Sundry Print Report

Well Name: ROSS DRAW	Well Location: T26S / R30E / SEC 33 / NENE / 32.004782 / -103.8797534	County or Parish/State: EDDY / NM
Well Number: 12	Type of Well: OIL WELL	Allottee or Tribe Name:
Lease Number: NMNM0480904A	Unit or CA Name:	Unit or CA Number:
US Well Number: 3001524793	Operator: WPX ENERGY PERMIAN LLC

Type of Action: Plug and Abandonment

WELLBORE DIAGRAM - CURRENT

WELLBORE DIAGRAM - PROPOSED

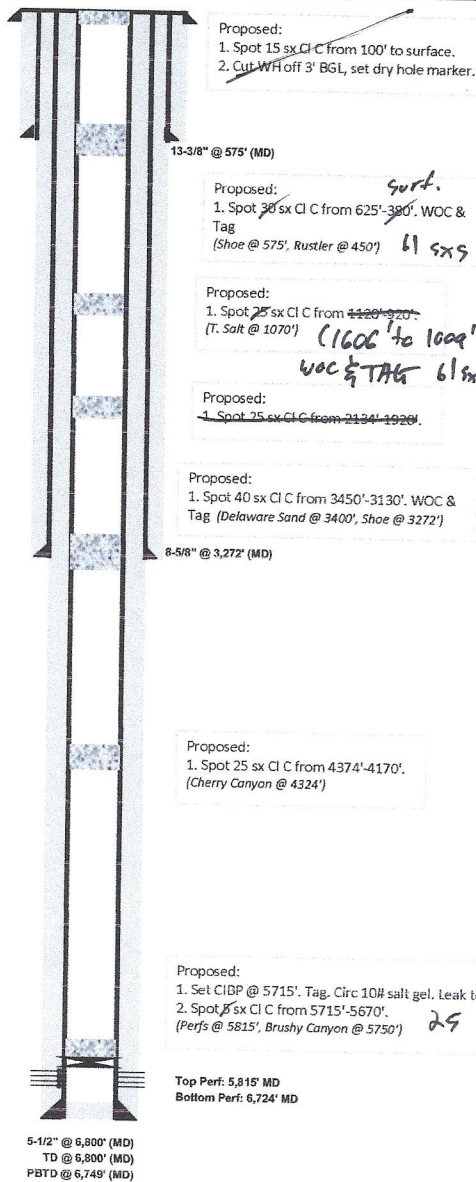
Plug Type	Top	Bottom	Length	Tag	Sacks	Cement Class	Notes
Surface Plug	0.00	100.00	100.00	Tag/Verify			
Fresh Water @ 490	435.10	540.00	104.90	If solid

13.375 inch- Shoe Plug	519.25	625.00	105.75	Tag/Verify	64.00	C	Spot cement from 625' to surface. Verify at surface.
Top of Salt @ 1070	1009.30	1120.00	110.70	Tag/Verify			
Base of Salt @ 1556	1490.44	1606.00	115.56	Tag/Verify	61.00	C	Spot cement from 1606' to 1009'. WOC and Tag.

8.625 inch- Shoe Plug	3189.28	3322.00	132.72	Tag/Verify			
Delaware @ 3374	3290.26	3424.00	133.74	If solid base no need to Tag (CIBP present and/or Mechanical Integrity Test), If Perf & Sqz then Tag, Leak Test all CIBP if no Open Perforations	40.00	C	Spot cement from 3450' to 3130'. WOC and Tag.
CIBP Plug	5680.00	5715.00	35.00	If solid base no need to Tag (CIBP present and/or Mechanical Integrity Test), If Perf & Sqz then Tag, Leak Test all CIBP if no Open Perforations	25.00	C	Set CIBP at 5715'. Leak test CIBP. Spot 25 sxs on top.
Perforations Plug (If No CIBP)	5765.00	6774.00	1009.00	Tag/Verify

5.5 inch- Shoe Plug	6682.00	6850.00	168.00	Tag/Verify

CIBP @ 5715.00

Created By	Condition	Condition Date
gcordero	Run CBL from 5715' to Surface	3/6/2025
gcordero	Submit Cement Bond Logs (CBL) prior to submittal of C-103P.	3/6/2025
